**Proposal for amendments to ECE/TRANS/WP.29/GRE/2013/13**  
(Supplement 25 to the 01 series of amendments to  
Regulation No. 6 (direction indicators))

The text reproduced below was prepared by the expert from OICA, to propose amendments to document GRE/2013/13 submitted by the experts from France and Germany. The modifications to the document GRE/2013/13 are highlighted in red, and marked in bold for new or strikethrough for deleted characters.

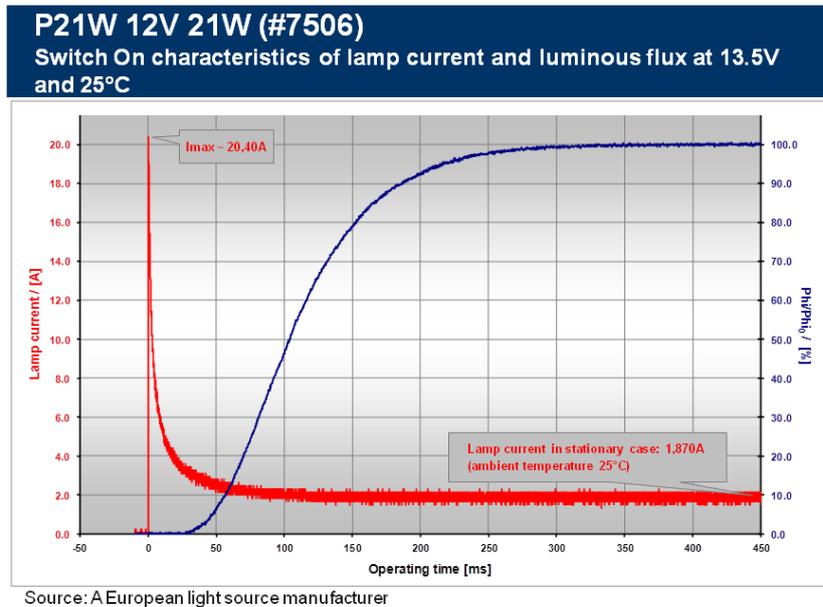
2. Movement of propagation (§5.6 (b)):

To add more clarity, it is proposed to use the same definition of "horizontal orientation" as in Regulation No. 48 (document ECE/TRANS/WP29/GRE/2013/14).

The ratio 1:1 is proposed because this is the limit between the horizontal and the vertical and, according to the shape of the body (curve, bump, convex, etc.), there is no visual impact and no safety issue between the ratio 1:1 or 10:6

Ratio 1:1

Ratio 10:6

**Horizontal orientation of a sequential progressive luminous intensity direction indicator means the ratio of the length of path of the movement in horizontal direction to that in vertical direction on the apparent surface [should not exceed] the value of [1:1]."**
